Town of Parker Community Development Department
Development Review Division
Attention: **Stacey Nerger**

Application Type: **Site Plan**
Status: **First Referral**
Application Name: Parker Town Hall Exemption Plat AMD3 L1 Town Hall Addition
Case/AP#: **SP23-097**
Referral Received: November 17, 2023
Comments Due: December 19, 2023

Review date: **December 12, 2023**
Plan reviewer: **Randall L. Capra, rcapra@parkeronline.org**
Phone: 303.805.3163

TOWN OF PARKER FIRE/LIFE SAFETY:	C REVIEWED FOR CODE COMPLIANCE w/COMMENTS
---	--

First submittal Comment:

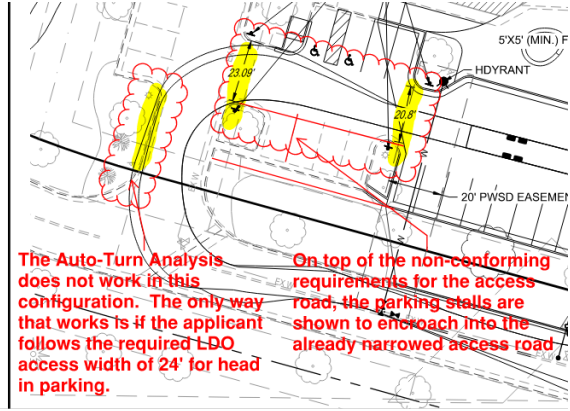
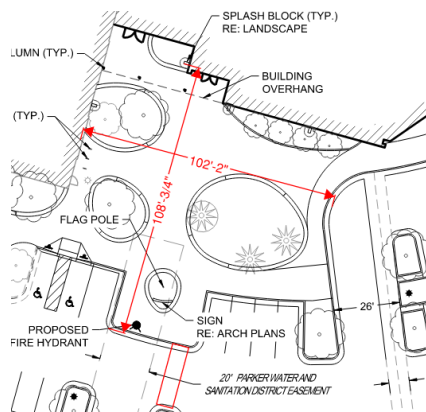
- 3. The applicant has only partially addressed the requirements of [21 IFC Appendix D for Aerial Apparatus Access roads. This sections requires that an aerial apparatus road be provided along the ENTIRE length of the building. In this case, only a portion of the reworked southern access was reworked to meet this requirement. Further, Appendix D requires that “access routes meeting this condition shall be located not less than 15 feet from the building and not greater than 30 feet from the building and shall be parallel to the entire side of the building”.

The portion of the access drive that does not meet the width requirement is shown below: *Not satisfied; applicant has not addressed this issue with the second submittal. The westerly portion of the access (see immediately below, does not meet aerial apparatus road requirements of the code (though I would allow the applicant to meet the required LDO requirements of the Town placing this part of the road at the required 24-feet in width. In addition, the auto-turn analysis does not work with the non-conforming access width. Address this issue as required when resubmitting. Satisfied; the applicant has addressed this issue with the third submittal.*

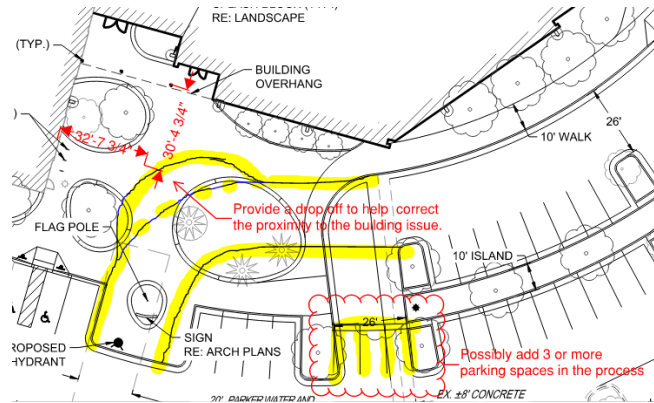
The portion of the access drive that does not meet the “proximity the building requirements is shown below: *Satisfied; the applicant has addressed this issue with the second submittal. Thank you!*

An option to solve the “proximity to the building” issue would be to extend the new main entry up towards the building and over to the north allowing for the access requirements to be met.

Note – another option would be to design the plaza to incorporate the required fire access road in the area identified above. Ultimately, it will be up to the design team to show how they can meet the requirements for aerial apparatus roads. Address this issue when resubmitting to ensure compliance with the requirements of the fire code.

Incorrect Block/Configuration:

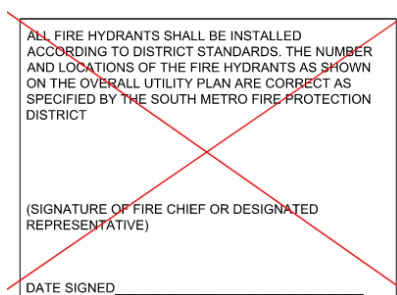
- The “approved” fire life safety signature block is required on both the cover sheet and the overall utility sheet of the utility plans; a copy of the block is provided at the end of this document. *Not satisfied with the second submittal; while the applicant has provided the correct signature block on the overall utility page, the applicant has not provided the correct signature block on the cover sheet of the utility drawings. When providing the correct signature block, do not modify the configuration of the block as doing so will not accommodate the electronic stamp that is used by Fire Life Safety to stamp the drawings. The configuration of the incorrect block used by the applicant is too narrow. See below:*

Marked up Utility Drawing

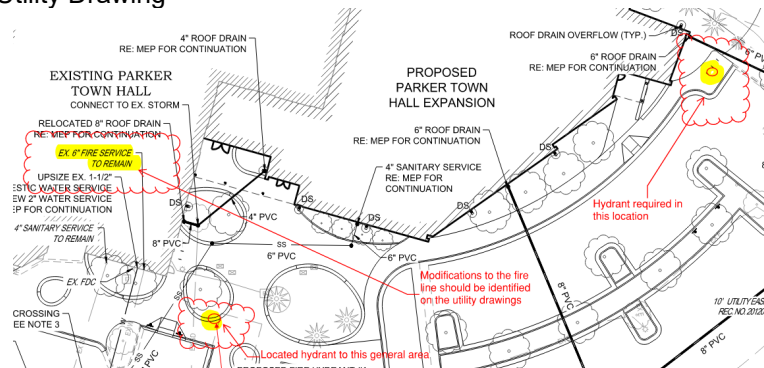
- **A fire hydrant is required to be provided on the east side of the new building (north end of inside parking lot). Satisfied; the applicant has addressed this issue with the second submittal. Thank you!**
- The fire hydrant located at the new main entry was to have been relocated to the west (based upon the aerial apparatus access road, I would suggest relocating the fire hydrant in an area shown below: **Satisfied; the applicant has addressed this issue with the second submittal. Thank you!**

Note – Based upon the modifications noted to meet the aerial appraisal requirements of the code, the fire hydrant located at the s/w corner of the existing building (that was to be relocated) shall be relocated in the area shown in the snapshot below. I will include both the access routes (whether plaza access or access road) with the proposed relocation for the fire hydrant as either scenario will require the hydrant to be relocated to the same general location.
